**FINAL**  
**ENVIRONMENTAL IMPACT STATEMENT**

## READER'S GUIDE TO THE DOCUMENT

This is a programmatic environmental impact statement (EIS) for adoption of the proposed Mineral Resource Management Plan (MRMP) for Vandenberg Air Force Base (VAFB).

**Figure 3.2-1A**  
**WATER WELL LOCATIONS**

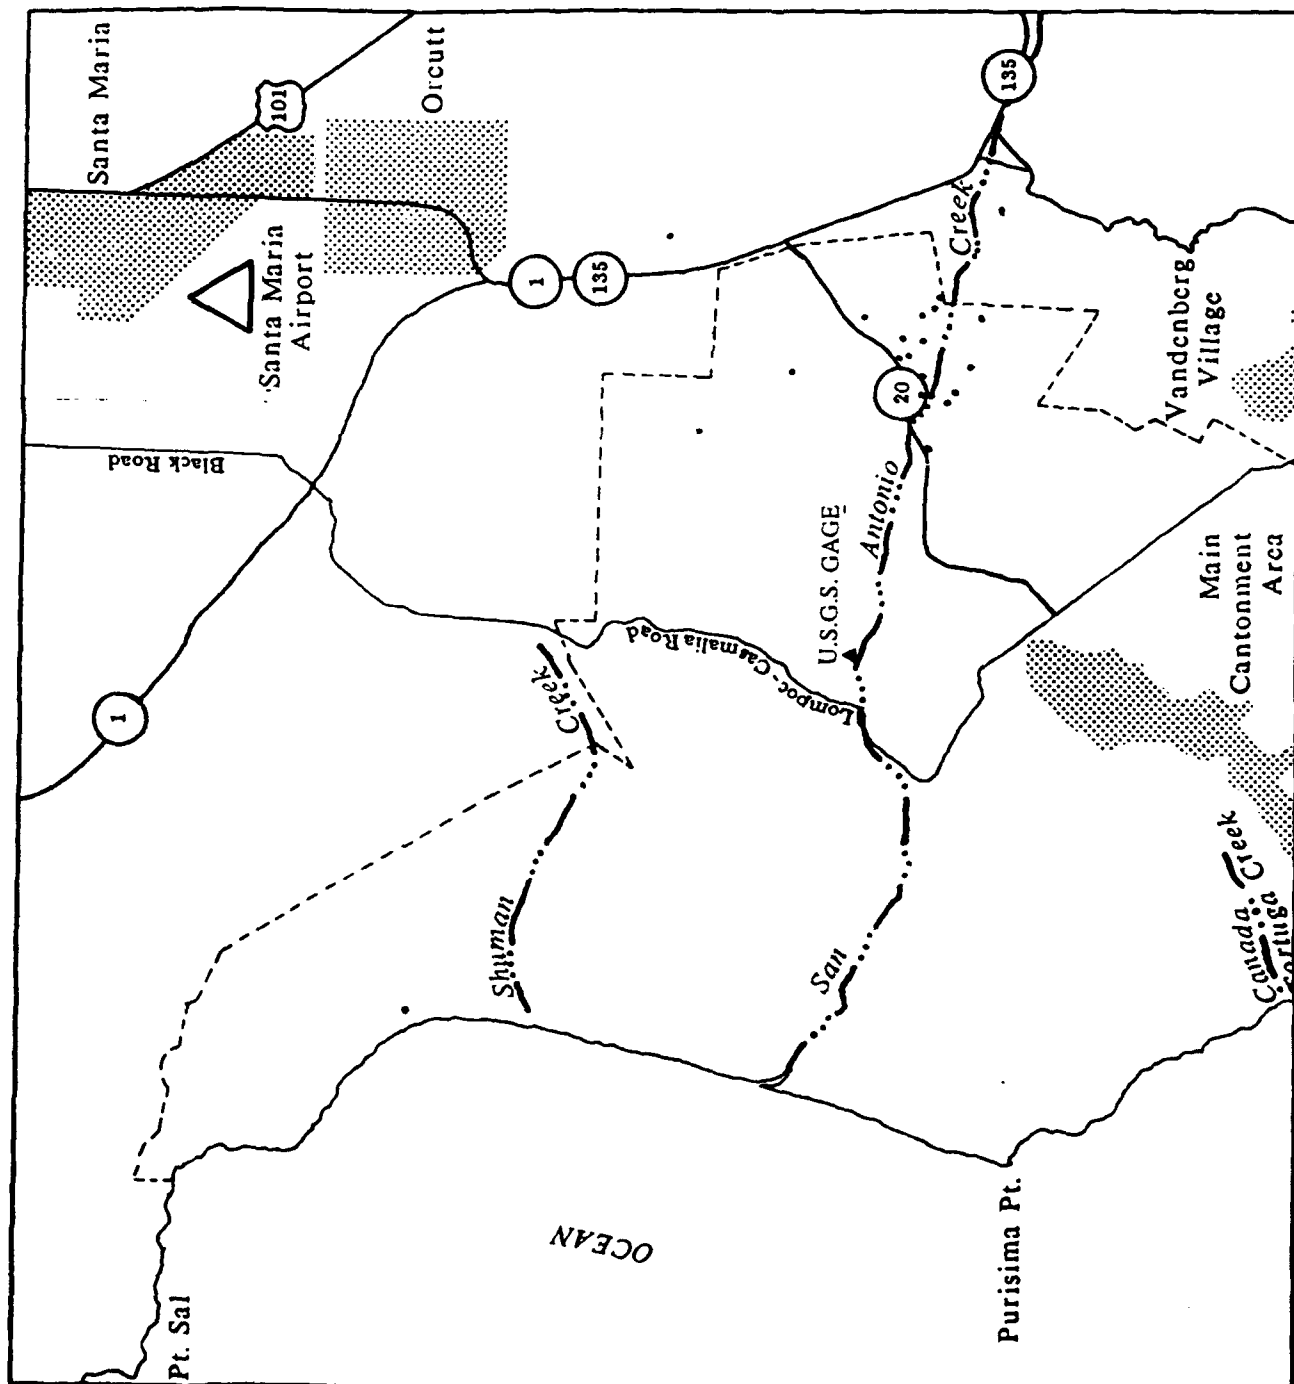
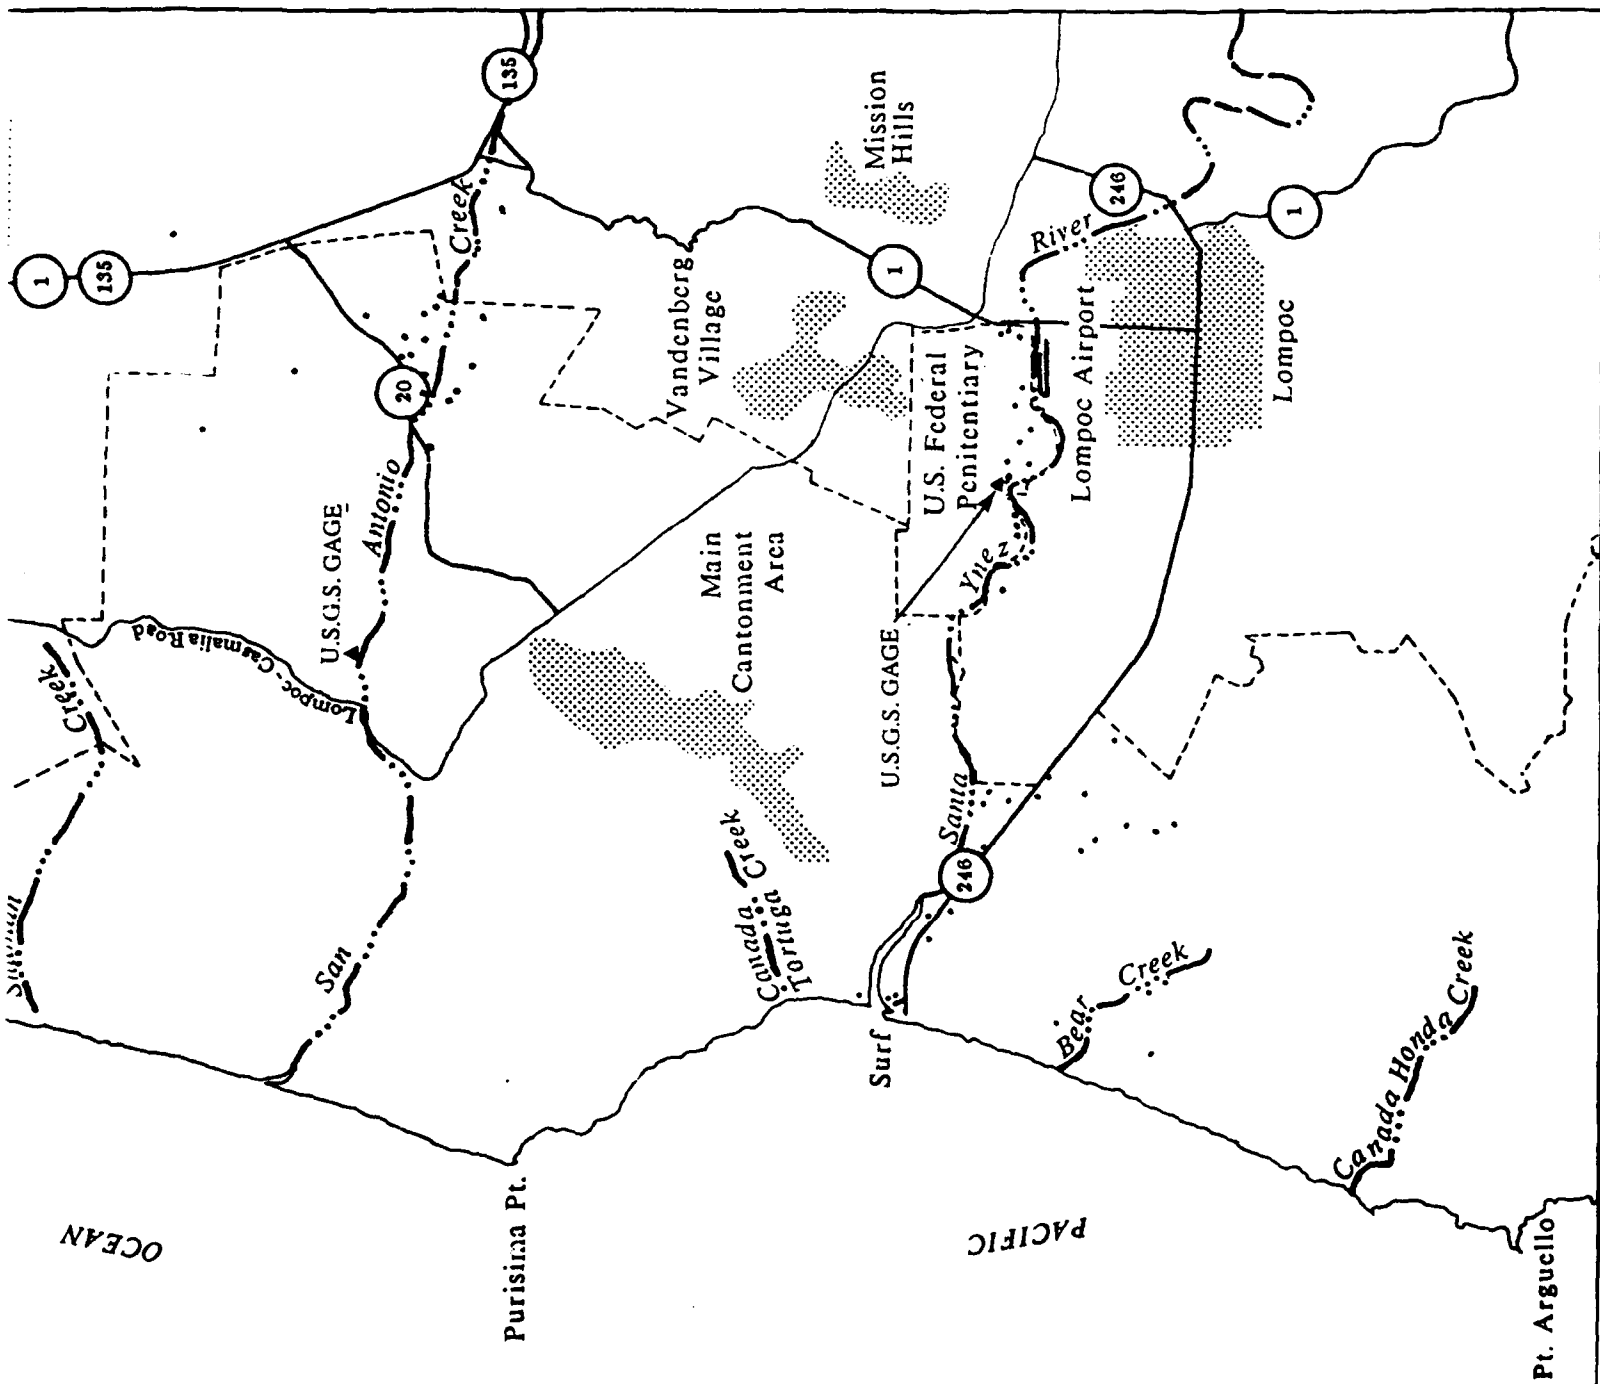
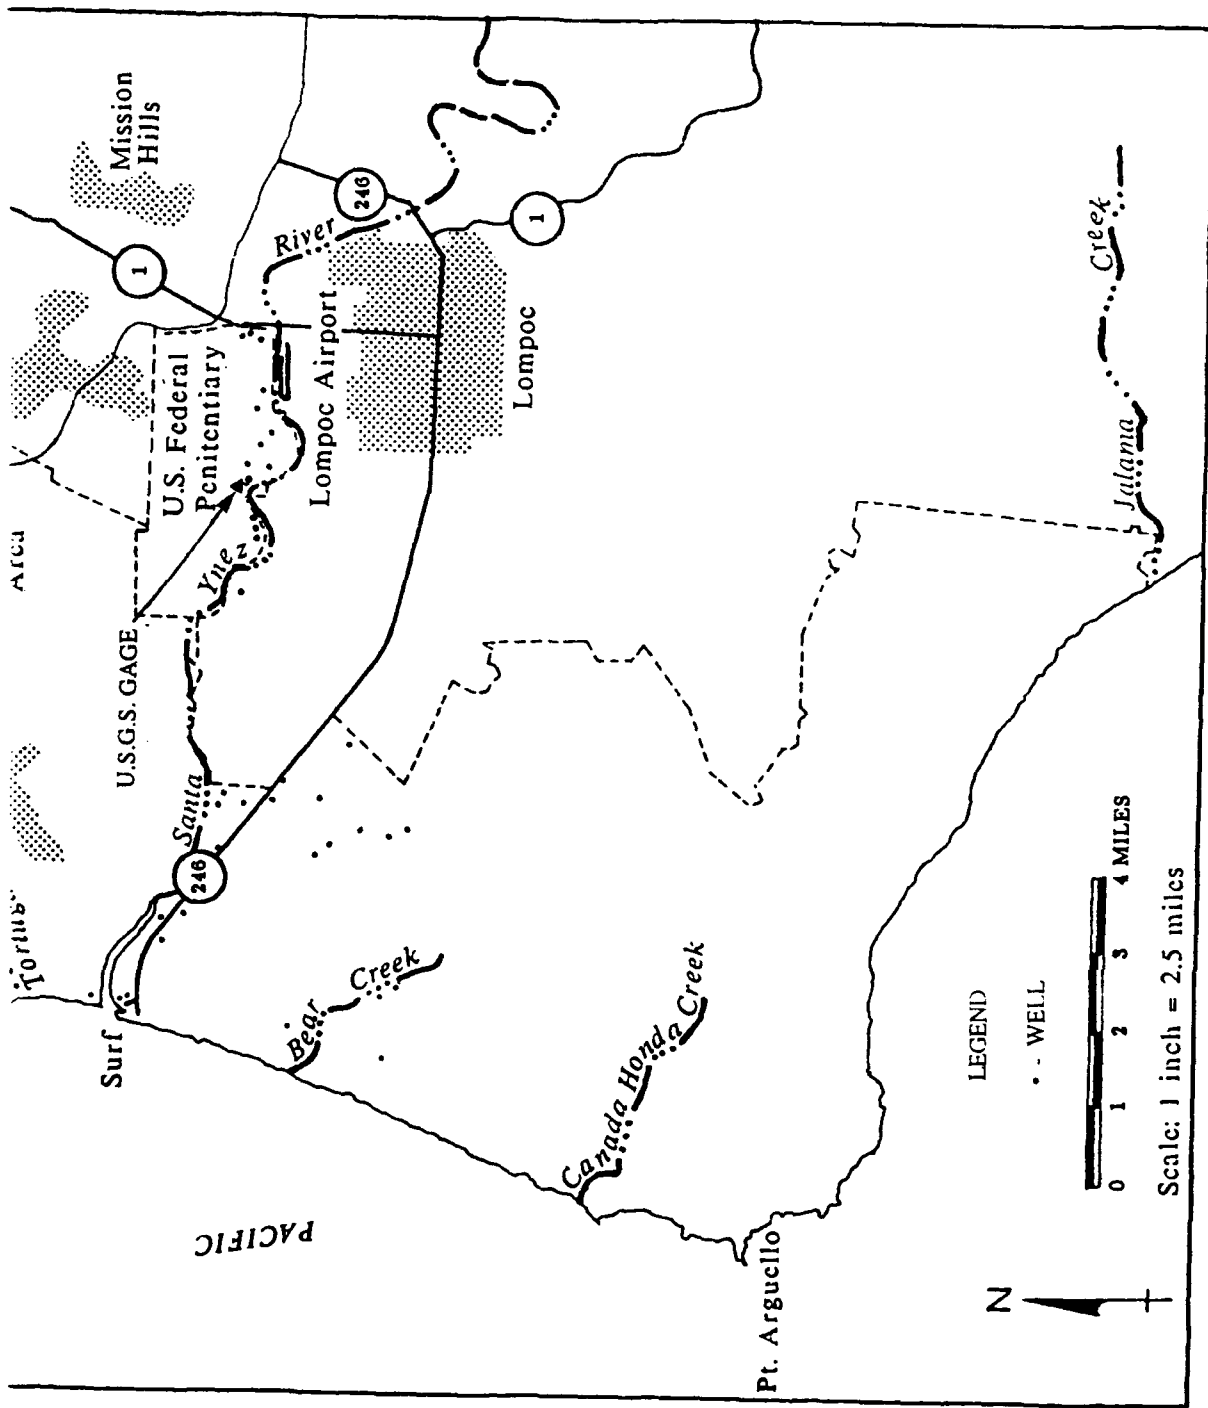
Section 3.2.4.1.2; page 3.2-8, add the following sentence at the end of paragraph one: "Water well locations are shown in Figure 3.2-1A." See the attached figure.

WQCB-5 Surface water and groundwater features are delineated in figures 3.2-1 and 3.2-2 of the DEIS, respectively. Water well locations are displayed on a new figure (Figure 3.2-1A of the errata for the EIS).

**Figure 3.3-2**  
**SANTA BARBARA COUNTY AIR QUALITY**  
**MANAGEMENT REGION**

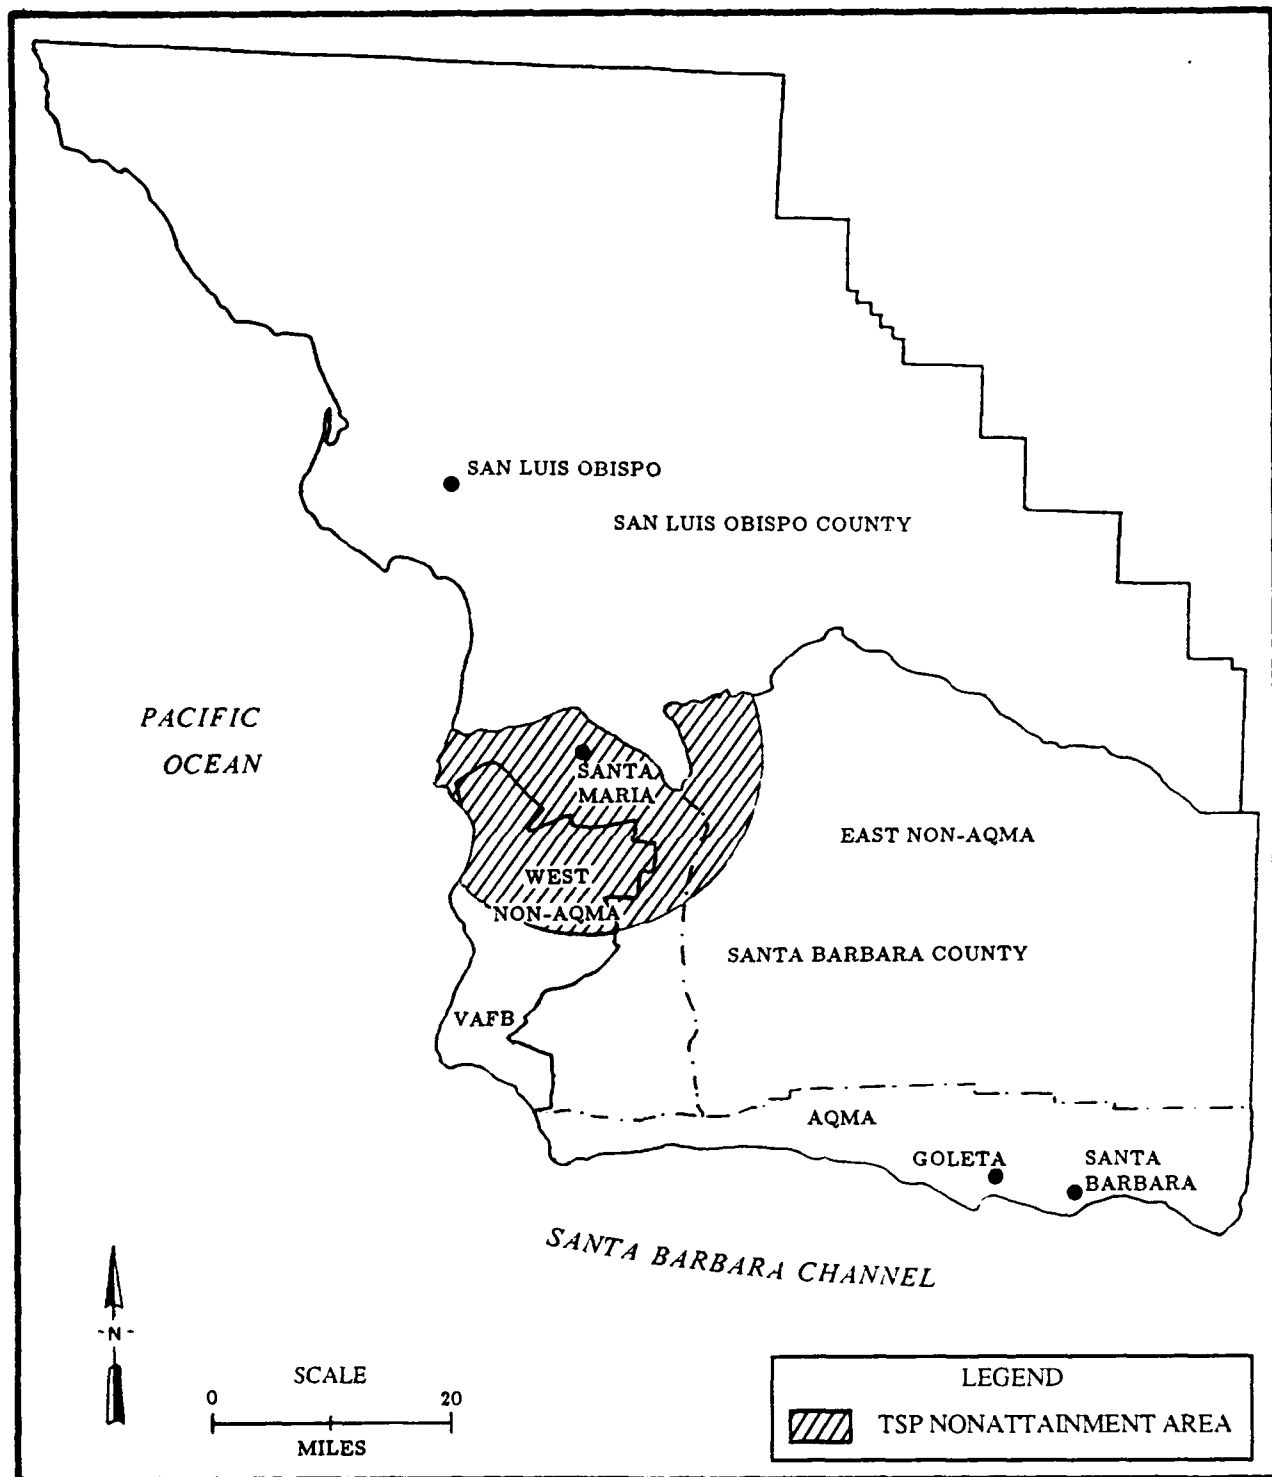
1. The TSP non-attainment area described on page 3.3-7 and depicted in Figure 3.3-2 mistakenly includes a portion of southern San Luis Obispo County. No areas in San Luis Obispo County are currently designated as Federal non-attainment areas for any pollutants. TSP measurements at Nipomo are well within Federal standards. The Nipomo monitoring station is located approximately nine miles north of Santa Maria. This correction should be noted in the FEIS.

Page 3.3-9, the TSP nonattainment area in Figure 3.3-2 has been corrected to only include the 15-mile radius from Santa Maria that is within Santa Barbara County.

Figure 4.9-3  
STEAM GENERATOR

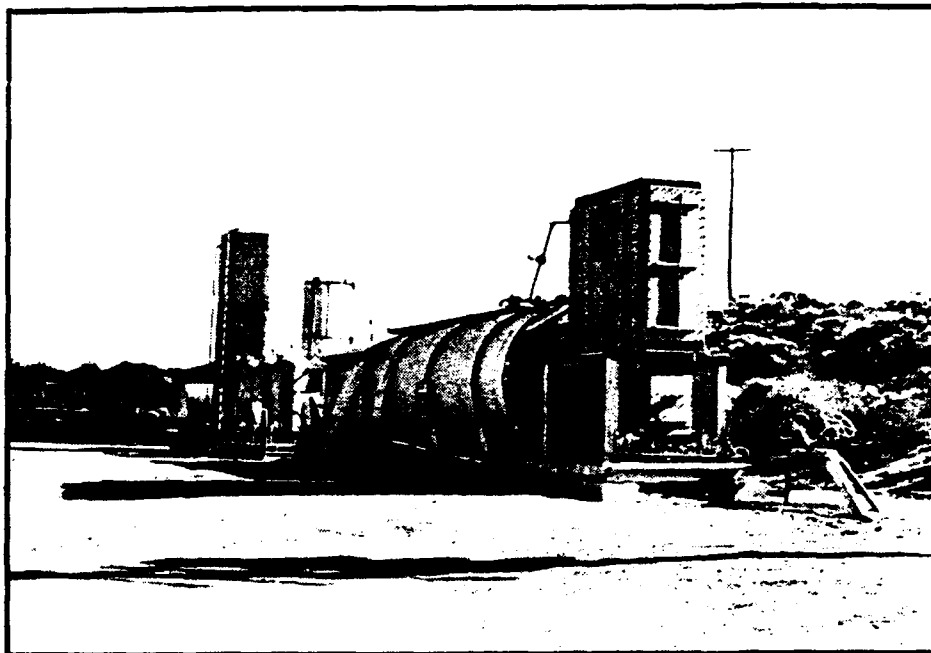
Figure 4.9-3 is incorrectly titled "H<sub>2</sub>S Scrubber". This photograph actually depicts a steam generator.

Figure 4.9-3 on page 4.9-5 has been retitled "Steam Generator" as shown on the attached figure.

Figure 5-1  
PHYSIOGRAPHIC FEATURES

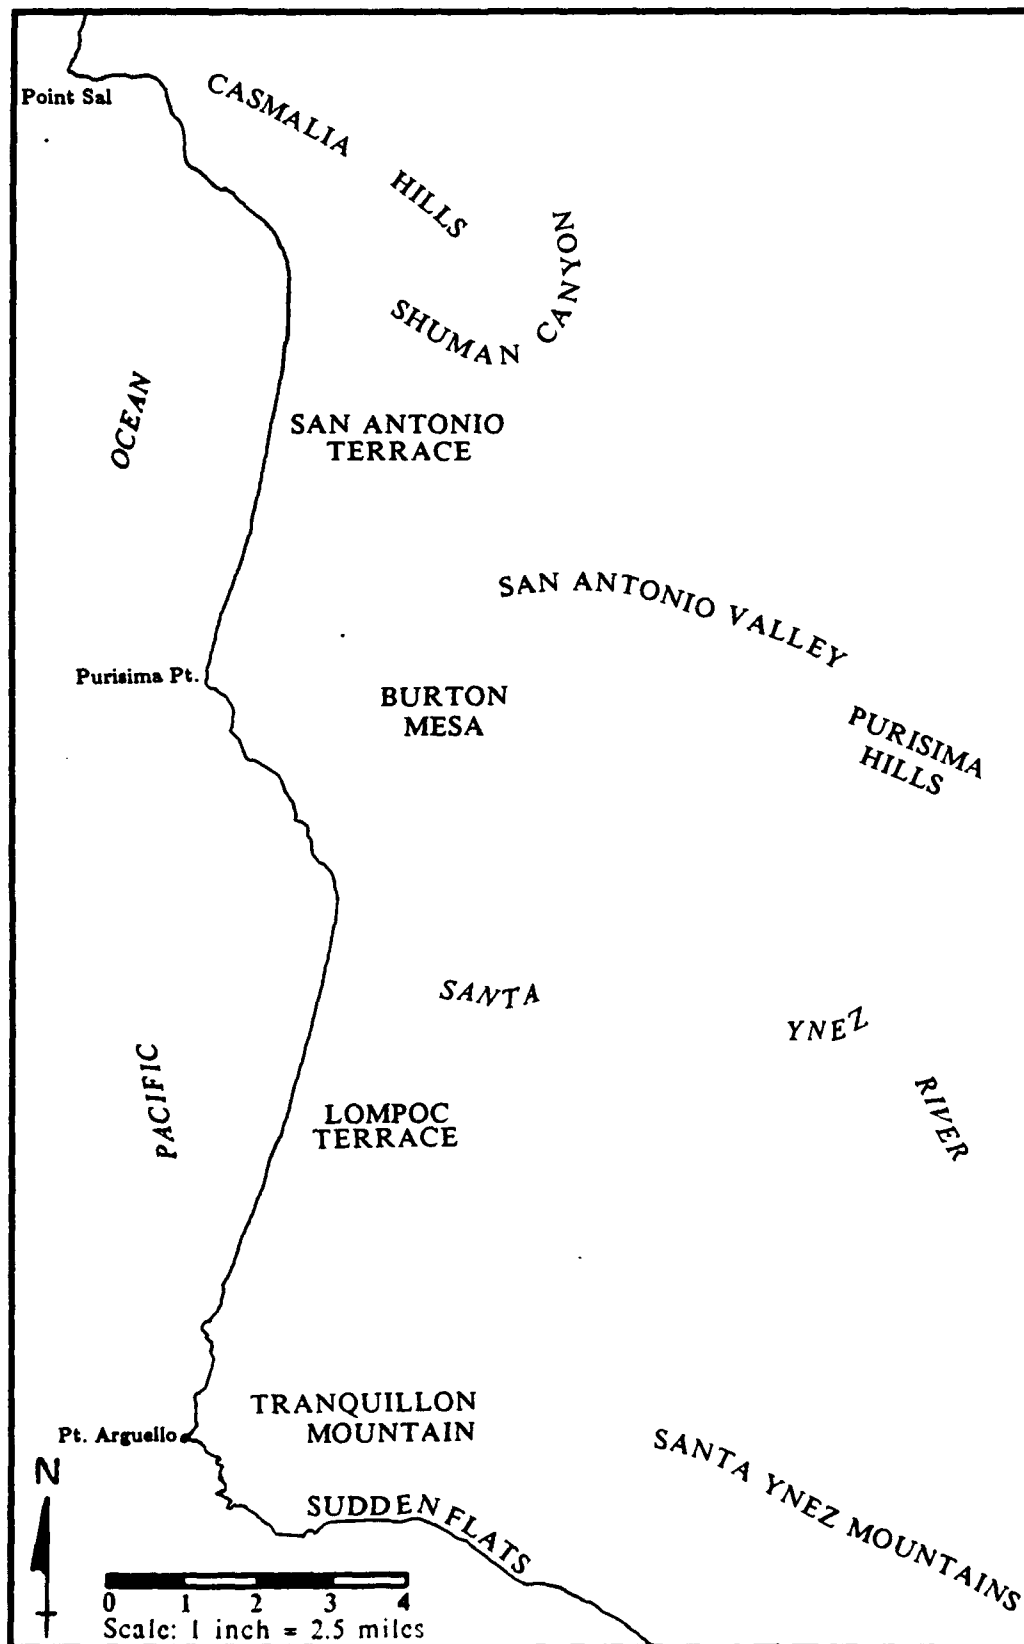
Figure 5-1 - Point Conception is incorrectly located

Figure 5-1 on page 5-2 has been revised. The words "Point Conception" no longer appear (see the attached figure).

Figure 6.9-7  
STEAM GENERATOR

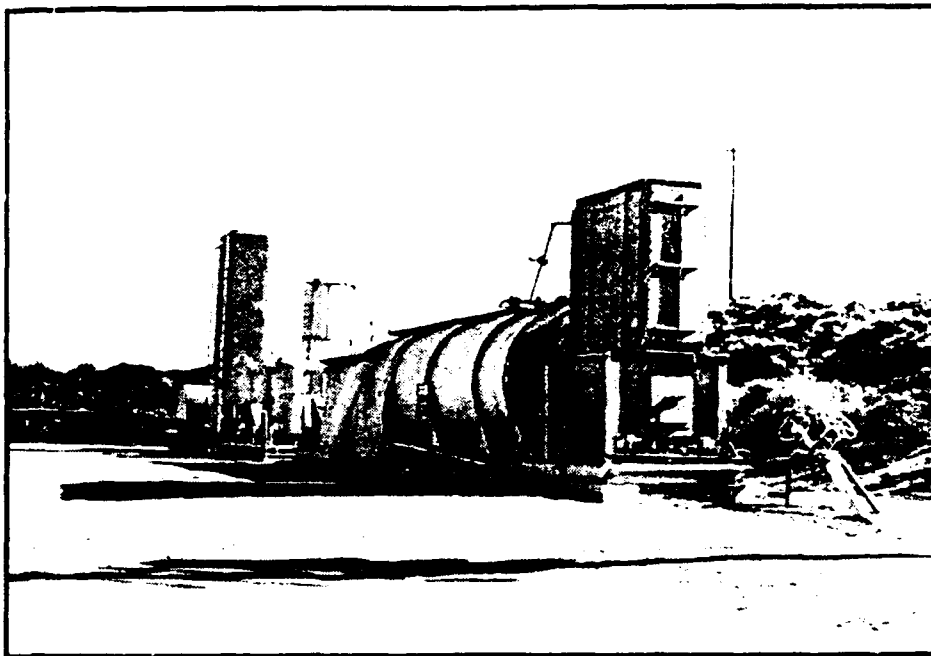
Paragraph 3 states that "electrical equipment...and installation of pipelines...would also effect air quality". Considering the subject, there Union-47 appears to be a typo and "visual" should be in place of "air" in the sentence. Figure 6.9-7 is incorrectly titled "H<sub>2</sub>S Scrubber". This photograph depicts a steam generator.

- Union-46 Refer to the response to comment Union-20.
- Union-47 Your comment is addressed in the MRMP errata. The word "air" in the sentence has been changed to "visual," and Figure 6.9-7 has been correctly titled, as shown in the MRMP errata.

Figure 6.9-7 on page 6.9-10 has been retitled "Steam Generator" as shown on the attached figure.
